Lighting Recommendations for the Social Security Administration Frank Hagel Federal Building in Richmond CA

Final Report

Figure 3. Illuminance distribution from indirect lighting system. Values calculated using Lumem Micro Version 6.0.

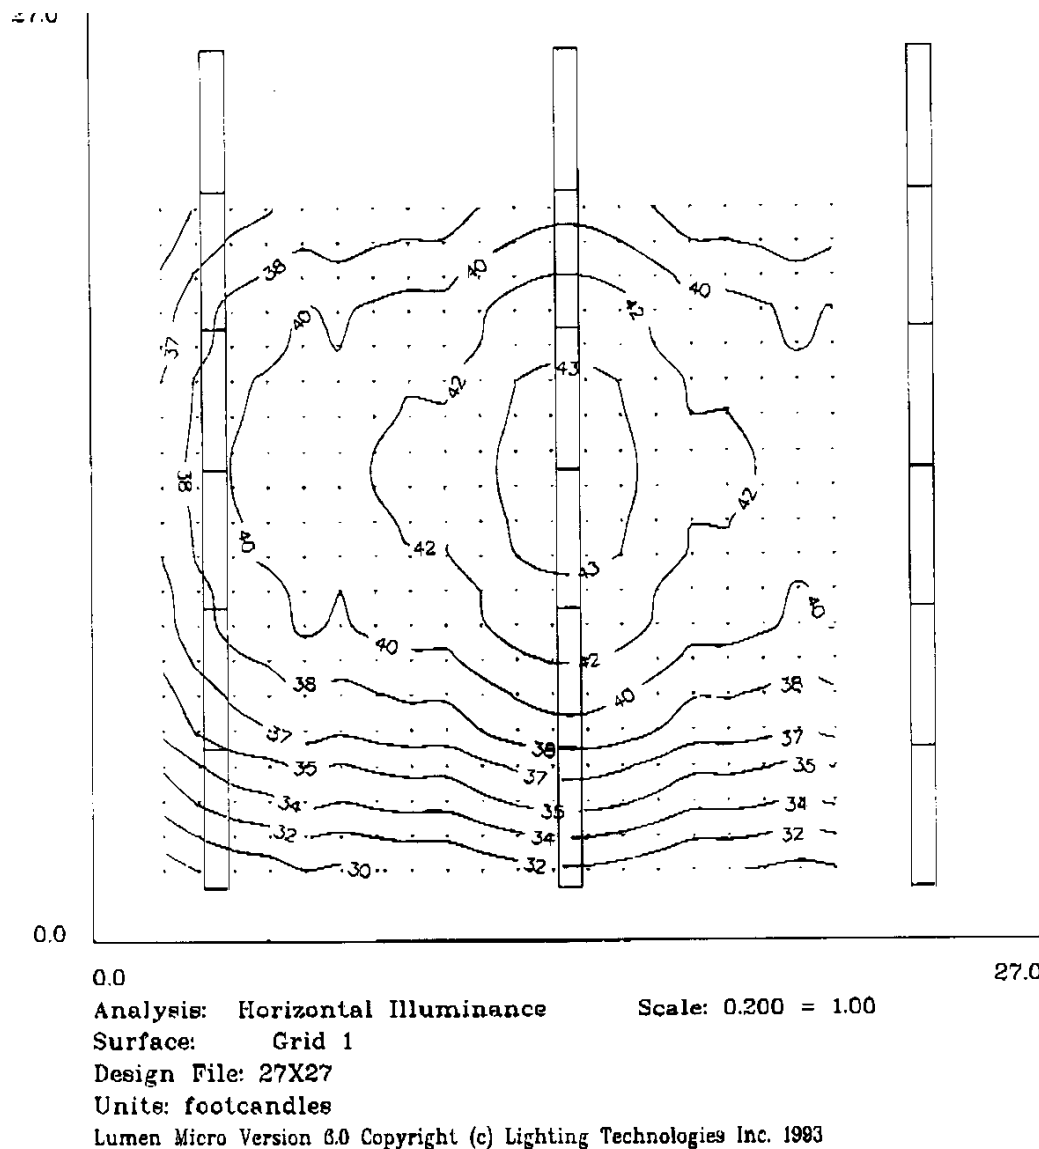
It should be noted that this solution requires a ballast with a high ballast factor (1.25) to obtain satisfactory light levels. Use of normal ballast factor will result in lower illumination levels. It should be noted that the above analysis does not include the effects of the partitions which will reduce the delivered light levels by about 20%.

To provide higher light levels than the 38 footcandle average will require supplemental task lights which could either be located under the storage cabinets or as articulated arm task lights that are mechanically connected to the desks. Because of variability and user preference, this report does not make specific recommendations for type of task light. The articulated arm task lights used in other portions of the building would serve this purpose well.
